**ZONING AMENDMENT,
& SUBDIVISION STAFF REPORT**

Date: September 6, 2007

<u>APPLICANT NAME</u>	TSS, LLC
<u>SUBDIVISION NAME</u>	Laughlin Industrial Park Subdivision
<u>LOCATION</u>	South side of Halls Mill Road, ¼ mile+ West of Halls Mill Service Road.
<u>CITY COUNCIL DISTRICT</u>	District 4
<u>PRESENT ZONING</u>	R-1, Single-Family Residence District
<u>PROPOSED ZONING</u>	I-1, Light Industry District
<u>AREA OF PROPERTY</u>	45.7 acre ± / 14 lots
<u>CONTEMPLATED USE</u>	Subdivision approval to create 14 lots, and Zoning approval to rezone the site from R-1, Single Family Residential to an I-1, Light Industry district to allow a light-industrial park. It should be noted, however, that any use permitted in the proposed district would be allowed at this location if the zoning is changed. Furthermore, the Planning Commission may consider zoning classifications other than that sought by the applicant for this property.
<u>REASON FOR REZONING</u>	Applicant is requesting rezoning of the site to create an industrial park.

SITE PLAN

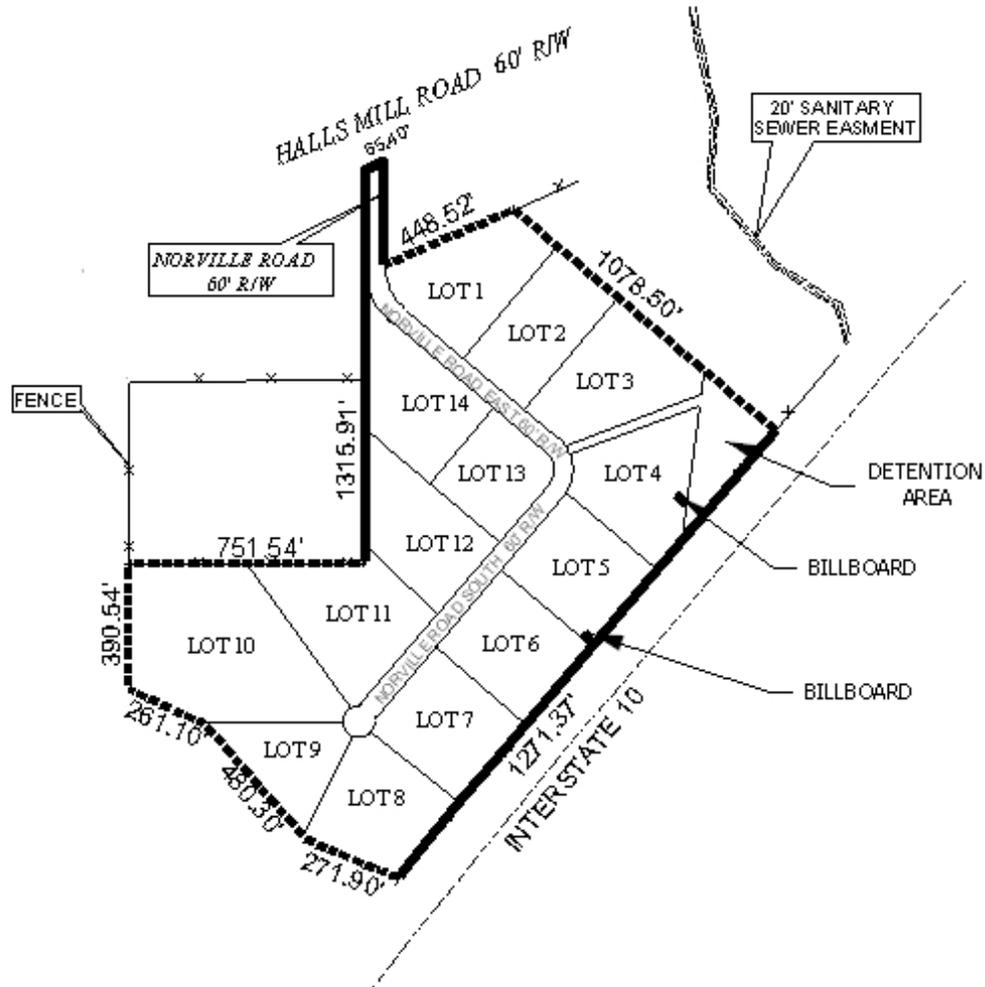
Show detention as common area. Show 500-year flood plain and minimum finished floor elevation on each lot touched by 500-year flood plain. It is the responsibility of the applicant to look up the site in the City of Mobile (COM) GIS system and verify if NWI wetlands are depicted on the site. If the COM GIS shows wetlands on the site, it is the responsibility of the applicant to confirm or deny the existence of wetlands on-site. If wetlands are present, they should be depicted on plans and/or plat, and no work/disturbance can be performed without a permit from the Corps of Engineers. Must comply with all storm water and flood control ordinances. Any work performed in the right of way will require a right of way permit.

The site abuts land-locked parcels to the West, however, these parcels abut other parcels under the same ownership (Norville) that have frontage onto a public street. The size of the land-locked parcels (34 + acres) warrant a street-stub from the subdivision proposed by the application at hand.

Access management is a concern due to the site abutting Interstate 10. All lots should be denied access to Interstate 10. Lots with 200 feet or less of frontage onto the proposed cul-de-sac should be limited to one curb-cut, while lots with greater than 200 feet of frontage should be limited to two curb-cuts, with the size, design and location of all curb-cuts to be approved by Traffic Engineering and conform with AASHTO standards.

Regarding the cul-de-sac, Section V.B.6. of the Subdivision Regulations states that "ordinarily, closed-end streets shall not be longer than 600 feet." Furthermore, the 2003 International Fire Code (IFC), as adopted by the City of Mobile, requires that closed-end streets exceeding 750 feet in length obtain special approval. It should also be pointed out that the 2003 IFC requires a 96-foot pavement diameter for the cul-de-sac, thus the cul-de-sac right-of-way should be expanded to accommodate the increased diameter width (right-of-way diameter recommended to be 120 feet). Fire-Rescue has additionally indicated that an intermediate turn-around may be required.

The 25-foot minimum building setback line, required in Section V.D.9., is not shown for the subdivision, but would be required on the final plat, if approved.

A detention basin is proposed for the subdivision. A note should be placed on the Final Plat, if approved, stating that maintenance of the detention basin common areas, and any other common areas, are the responsibility of the subdivision's property owners.

It appears that a portion of the site may contain wetlands and be within the floodplain for Halls Mill Creek. The potential presence of wetlands and floodplains indicate that the area may be environmentally sensitive; therefore, the approval of all applicable federal, state and local agencies would be required prior to the issuance of any permits or land disturbance activities.

- 1) placement of a note on the final plat stating that all lots are denied access to Interstate 10;
- 2) placement of a note on the final plat stating that lots with 200 feet or less of frontage onto the proposed cul-de-sac are limited to one curb-cut, while lots with greater than 200 feet of frontage are limited to two curb-cuts, with the size, design and location of all curb-cuts to be approved by Traffic Engineering and conform to AASHTO standards.

- 3) provision of a street-stub to the larger of the two adjacent land-locked parcels;
- 4) compliance with Fire-Rescue comments, including the redesign of the cul-de-sac to comply with the requirements of the 2003 International Fire Code, as adopted by the City of Mobile, and the obtaining of approval in writing from Mobile Fire-Rescue for the design (if an intermediate turn-around is required) and length of the cul-de-sac prior to the signing of the final plat;

- 5) depiction of the 25-foot minimum building setback line from all street frontages (including Interstate 10), as required by Section V.D.9. of the Subdivision Regulations;

- 6) the labeling of each lot with its size in square feet, or placement of a table on the plat with the same information;
- 7) placement of a note on the final plat stating that the maintenance of the detention common area is the responsibility of the property owners;

- 8) compliance with Engineering comments (*Show detention as common area. Show 500-year flood plain and minimum finished floor elevation on each lot touched by 500-year flood plain. It is the responsibility of the applicant to look up the site in the City of Mobile (COM) GIS system and verify if NWI wetlands are depicted on the site. If the COM GIS shows wetlands on the site, it is the responsibility of the applicant to confirm or deny the existence of wetlands on-site. If wetlands are present, they should be depicted on plans and/or plat, and no work/disturbance can be performed without a*

permit from the Corps of Engineers. Must comply with all storm water and flood control ordinances. Any work performed in the right of way will require a right of way permit.)
